UNITED STATES PATENT AND TRADEMARK OFFICE

APPLICATION NO.	FILING DATE	FIRST NAMED INVENTOR	ATTORNEY DOCKET NO.	CONFIRMATION NO.
10/709,973	06/10/2004	Andrew Scott Argersinger	GEMS 0242 PUS	3972
27256	7590	05/19/2006	EXAMINER	
ARTZ & ARTZ, P.C. 28333 TELEGRAPH RD. SUITE 250 SOUTHFIELD, MI 48034			RAMIREZ, JOHN FERNANDO	
			ART UNIT	PAPER NUMBER
			3737

Office Action Summary	Application No.	Applicant(s)	
	10/709,973	ARGERSINGER ET AL.	
	Examiner	Art Unit	
	John F. Ramirez	3737

DETAILED ACTION

Fig. 12

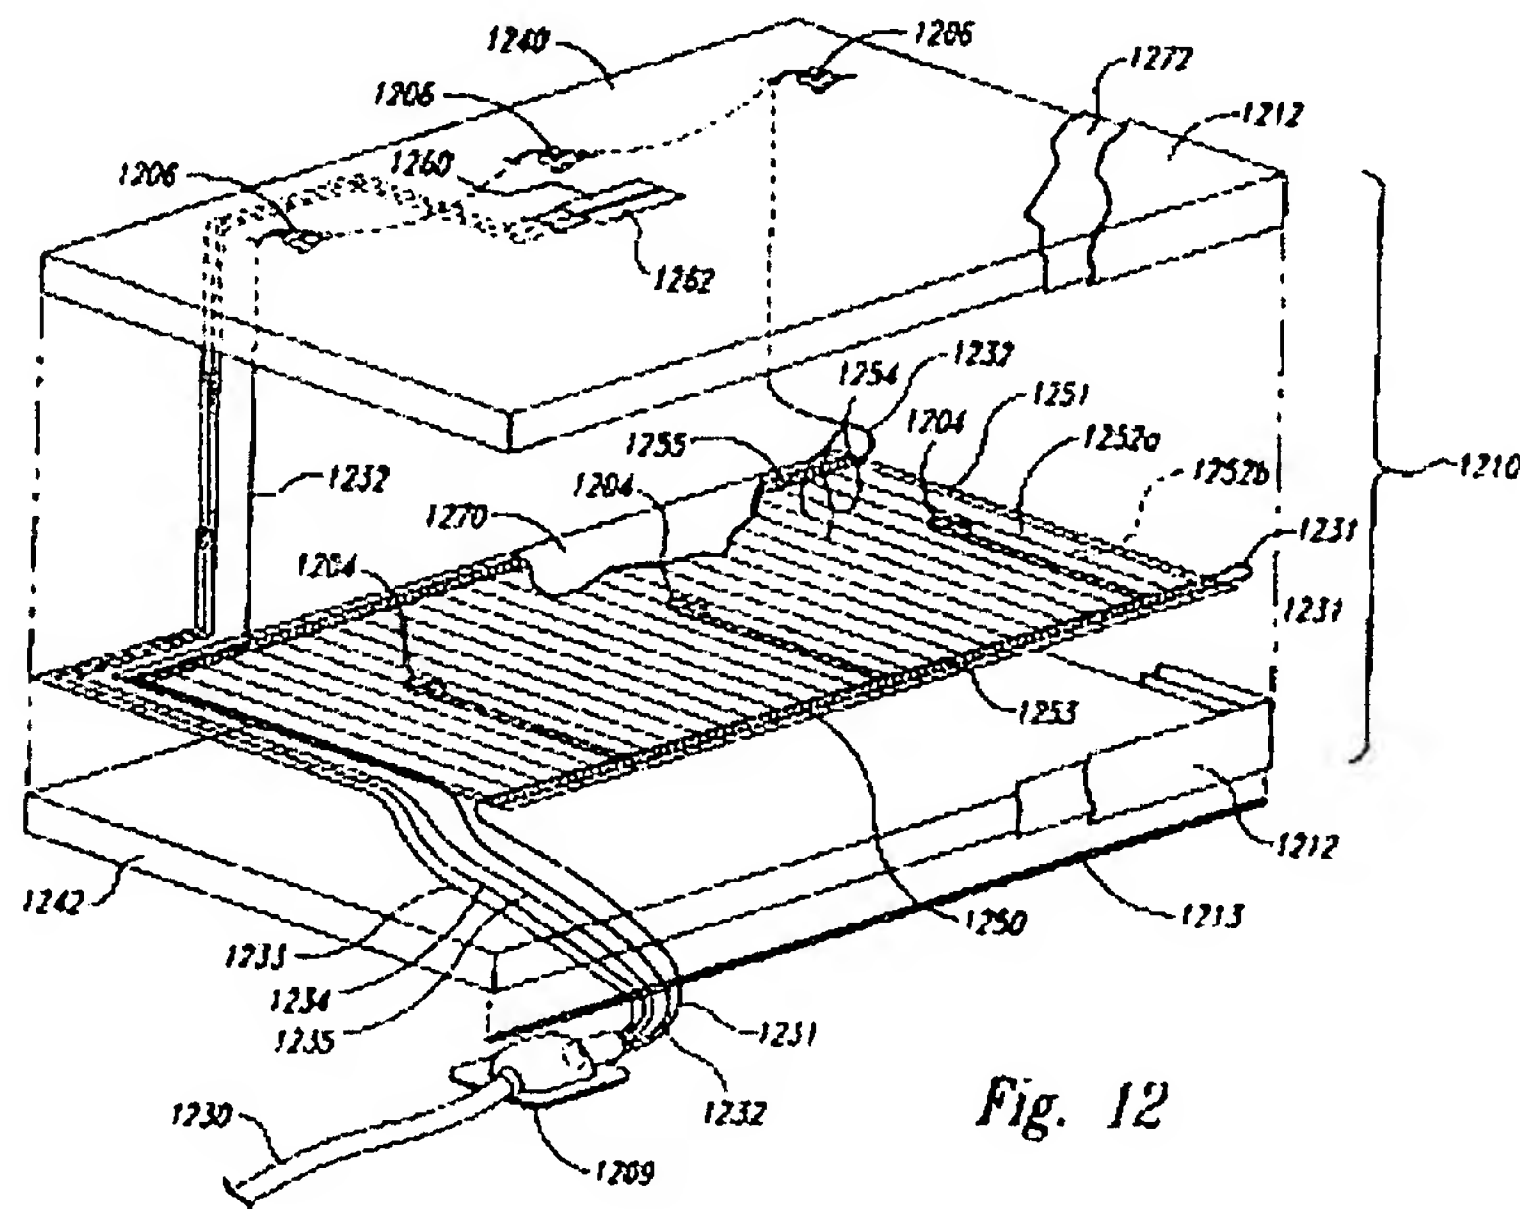
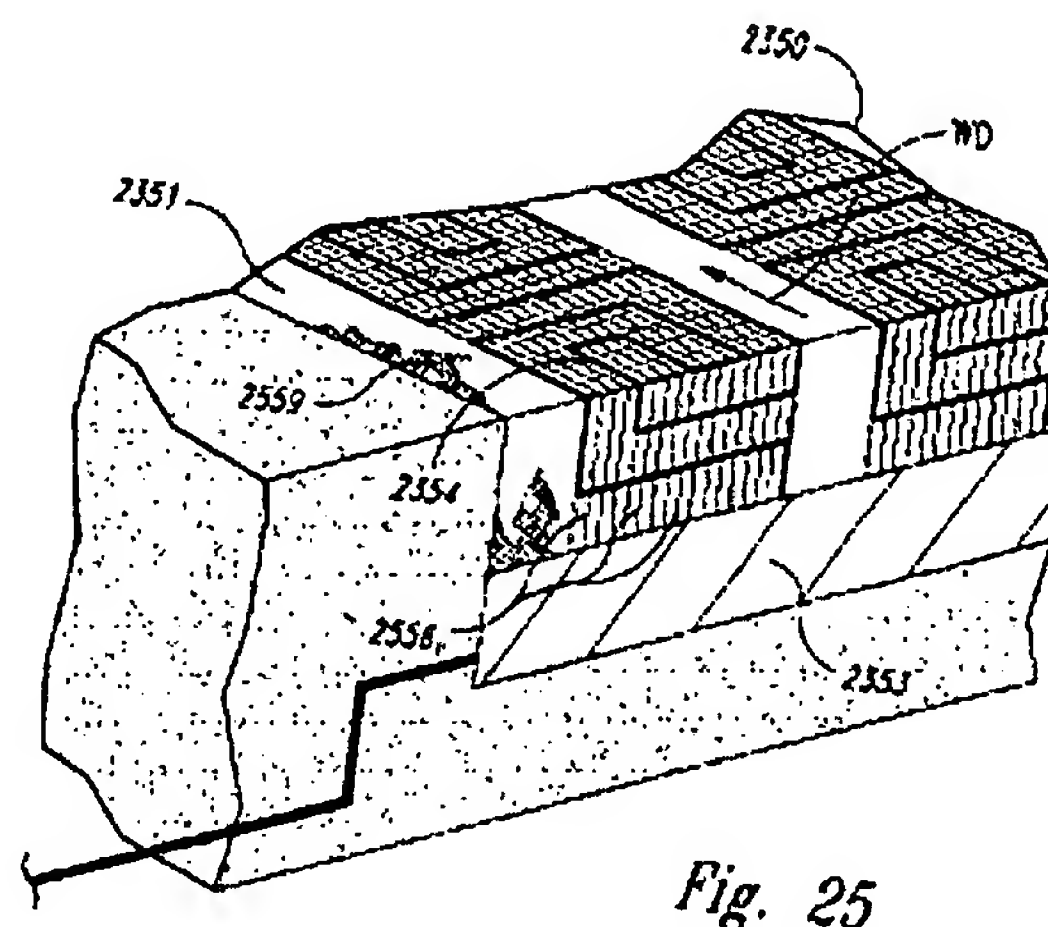
The Wyatt et al. patent teaches, a thermo sensor assembly positioned to monitor temperature at the patient exposure surface, a logic (fig. 1, 120) that is in communication with the thermo sensor (fig. 12, 1260, 1262) assembly and the thermo generating element (fig. 12, 1250), and said logic (fig. 1, 120) adapted to remove power from the thermo generating element (col. 18, lines 27-46).
